Committee of Experts on the Transport of Dangerous Goods and on the Globally Harmonized System of Classification and Labelling of Chemicals

Design proposal for the standard detonator in the Manual of Tests and Criteria

Transmitted by the Institute of Makers of Explosives (IME)

Proposed Amendments to Proposed Text in ST/SG/AC.10/C.3/2015/26

Figure A1.1: STANDARD DETONATOR (EUROPEAN) [DWB4]

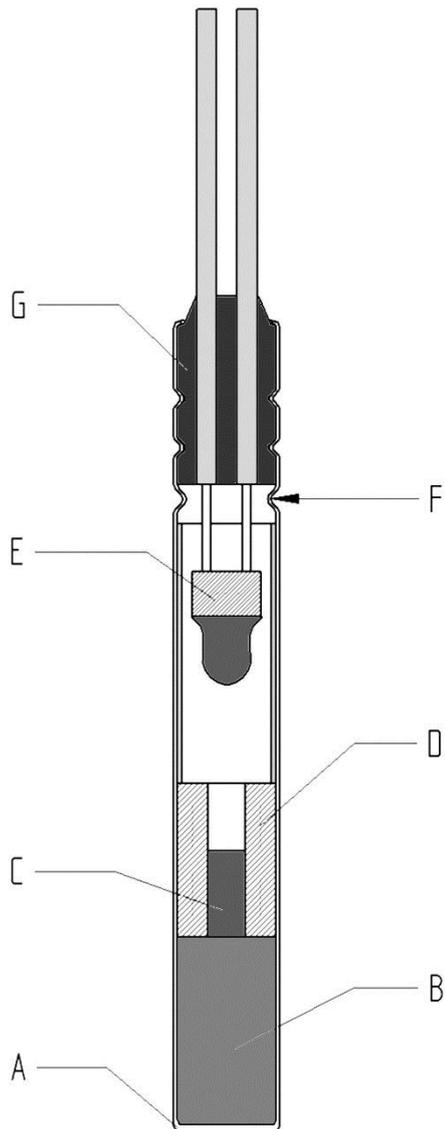
According to the elements of the standard detonator indicated in Figure A1.1 by letters A-G the following specifications apply:

The ~~blasting cap~~ detonator shell shall be hollow-drawn from either copper (with not more than 5% zinc, where an alloy is used) or aluminium. The cap shall have an outer diameter of 7.0 mm ~~to 7.6 mm~~^(DWR) ± 0.1 mm. ~~The wall thickness shall be 0.24 mm ± 0.05 mm.~~ The thickness at the bottom of the cap shall be 0.42 mm ± 0.05 mm.

The secondary charge shall be PETN and with a mass of ~~0.60 g ± 0.01~~ ~~0.450 to 0.475~~^(DWR) g and pressed at a minimum of 26 MPa. The secondary charge is pressed into the bottom of the ~~blasting cap~~ detonator and shall have no gaps or air spaces.

The primary charge shall be ~~fully contained in the tube (D) and shall consist of not more than 0.10 g~~ of a primary explosive (preferably lead-free). ~~The primary charge usually will not fully fill the space inside the tube (D).~~ It needs to be in direct contact to the secondary charge.

~~This tube acts as protection of the primary charge against fragments which could cause a sympathetic detonation. The length of the tube shall be 10-15 mm, the outer diameter shall be such to fit snugly into the detonator cap, the wall thickness of the tube shall be not less than 1 mm, and the inner diameter is typically not less than 2 mm.~~

~~The fuse head shall have a protection against electrostatic discharge. The fuse head charge shall contain not more than 50 mg of a primary explosive (preferably lead free). The distance between the fuse head (E) and the tube (D) shall be in the range of 3-10 mm. The electric parameters of the bridge wire in the fuse head shall be of an electrically insensitive type. The no fire current shall be 0.45 A (Ampere) or greater, the no fire impulse shall be 8 mJ/Ohm or greater.~~

~~There shall be a narrow air gap ("spark gap") between the exposed lead wires of the fuse head (E) and the blasting cap (A). The plug (G) must leave room for a spark to the lead wires, and a crimping may be used to generate a fold to even further narrow the gap. The distance between the fuse head and the nearest metallic parts shall be sufficiently large, such that the spark gap is functional. Suggest: Other proven methods of electrostatic protection shall be used for the construction of the detonator.~~

~~The plug tightly surrounds the lead wires and forms together with the crimping of the blasting cap (A) a tight closure of the blasting cap.~~^[DWB]

~~Where the tube (D) is made out of sufficiently strong steel it “survives” the functioning of the detonator. I. e. it will stay intact and will not form fragments, which would be detrimental to the intended effect. The tube (D) shall not fragment upon functioning.~~

~~Protection of the fuse head (E) against electrostatic discharge can be achieved in different ways. The fuse head may be surrounded by a plastic tubing, which fits without play inside the detonator cap (A). This can be done to generate a long path for a discharge between fuse head and cap. In Figure A1.1 such a plastic tube is indicated to show this to be a permissible variation. This plastic tube is optional and protection of the fuse head can also be achieved by conductive coating.~~

~~Figure A1.1 shows a closing plug (G) with straight lead wires. Twisted lead wires within the closing plug are also common and irrelevant for the functioning or safety of the detonator. The plug (G) may extend outside the blasting cap (A), which is also irrelevant for the functioning. The plug (G), however, shall at minimum be aligned to the open end of the blasting cap (A).~~

~~—— 2. —— Schematic drawing of the standard detonator~~

The detonator shell shall be hollow-drawn from either copper (with not more than 5% zinc, where an alloy is used) or aluminium. The cap shall have an outer diameter of 7.0 mm to 7.6 mm. The thickness at the bottom of the cap shall be $0.42 \text{ mm} \pm 0.05 \text{ mm}$.

The secondary charge shall be PETN and with a mass of 0.450 to 0.475 g and pressed at a minimum of 26 MPa.. The secondary charge is pressed into the bottom of the detonator and shall have no gaps or air spaces.

The primary charge shall be of a primary explosive (preferably lead-free). It needs to be in direct contact to the secondary charge.
